NUMBER: 11-001-14

GROUP: Exhaust System

Weld Length on Exhaust Hanger Bracket Too Short

2013	DD	Ram 3500 Cab Chassis
2013	DP	Ram 4500/550 Cab Chassis

Fig. 1 SCR Hanger Bracket

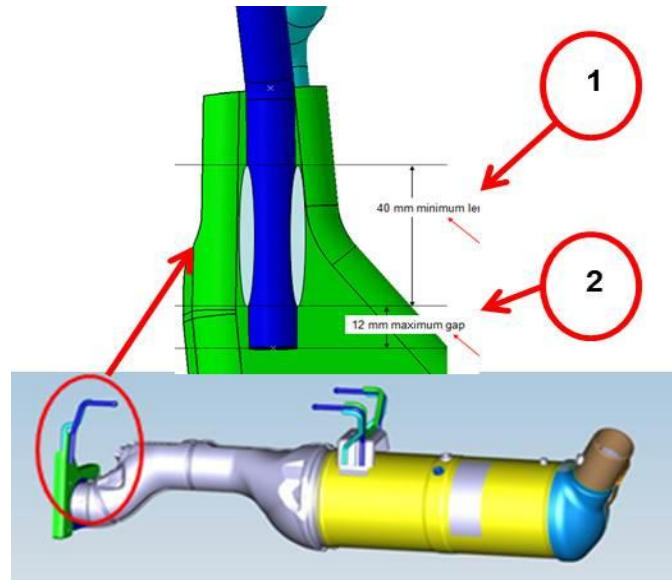
The exhaust inlet hanger bracket on suspect vehicles may have the weld securing the bracket to the hanger too short. A short weld may lead to premature hanger failure.

- 1 - Minimum Weld Length is 40mm (1.57 in.)
 - 2 - Minimum Weld Distance From Rod End is 12mm (0.47 in.)
-

Fig. 2 Weld End Gap

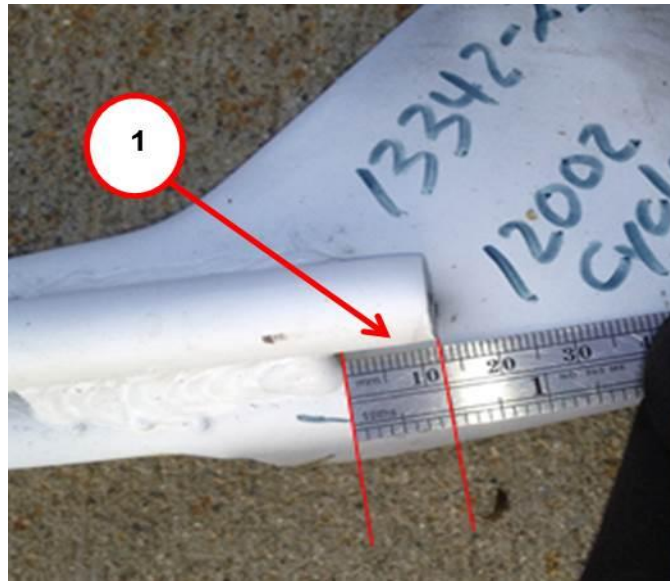
3. Measure the distance from the end of the hanger rod to where the weld starts to secure the rod to the bracket (Fig. 2).

1 - Minimum Weld Distance From Rod End is 12mm (0.47 in.)

4. Is the distance 12mm (0.47 in.) or less?
 - a. YES>>>Continue to the next step.
 - b. NO>>>Proceed to [Step #7](#) (dealer repair) or [Step #19](#) (sublet repair).
5. Measure the length of the rod to bracket weld on each side of the rod ([Fig. 3](#)).

Fig. 3 Weld Length

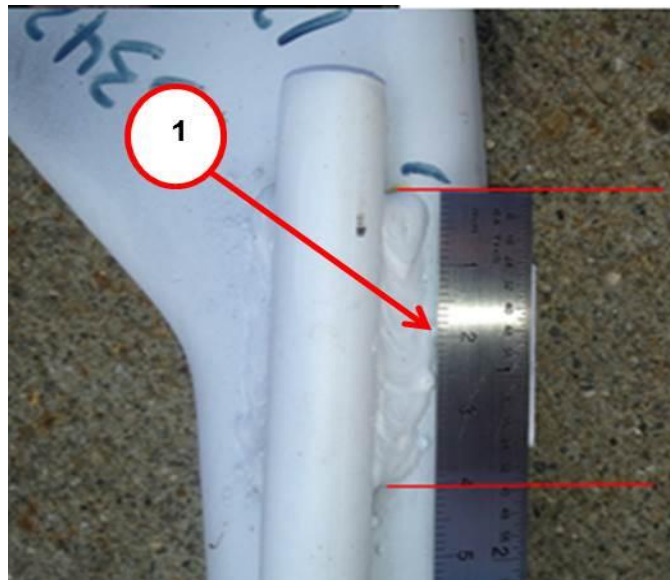
1 - Minimum Weld Length is 40mm (1.57 in.)

6. Is the length of the rod to bracket weld 40mm (1.57 in.) or longer on each side?
 - a. YES>>>Inspection complete. No additional work is necessary.
 - b. NO>>>Proceed to the next step.

Fig. 6 Reinforce Weld to a Length of 60mm

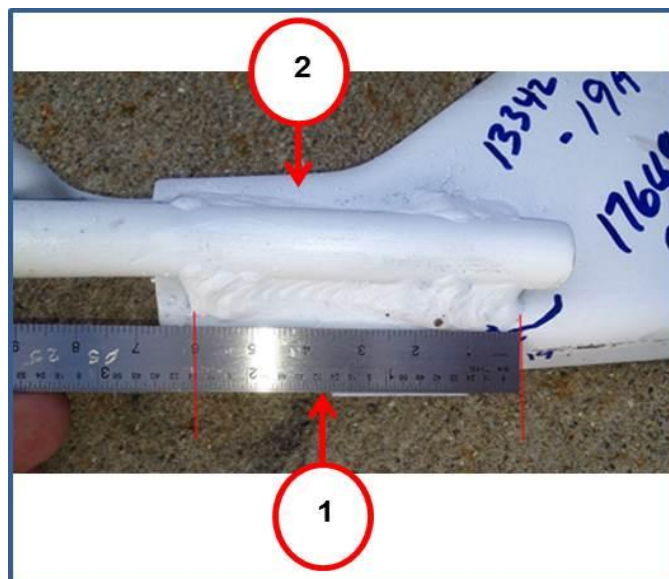
- 20. Using a clean rotary wire-brush, remove any rust and/or debris from the area to be welded and the area where the ground clamp will be attached. Attach the ground clamp to either the hanger rod or the bracket.
- 21. Add additional flare-groove weld length with GTAW ("TIG" weld) using a 90-degree torch with a stub back-cap adding 409SS wire to reach a minimum required length (60mm (2.36 in.)) on each side of the hanger rod ([Fig. 6](#)). The GTAW power supply should be set to a mode with High Frequency (HF) in Start Only: HF shuts off shortly after the arc is established. This gives better protection to electronic system components.

1 - Increase Weld Length to 60mm (2.36 in.)

2 - Increase Weld Length to 60mm (2.36 in.)
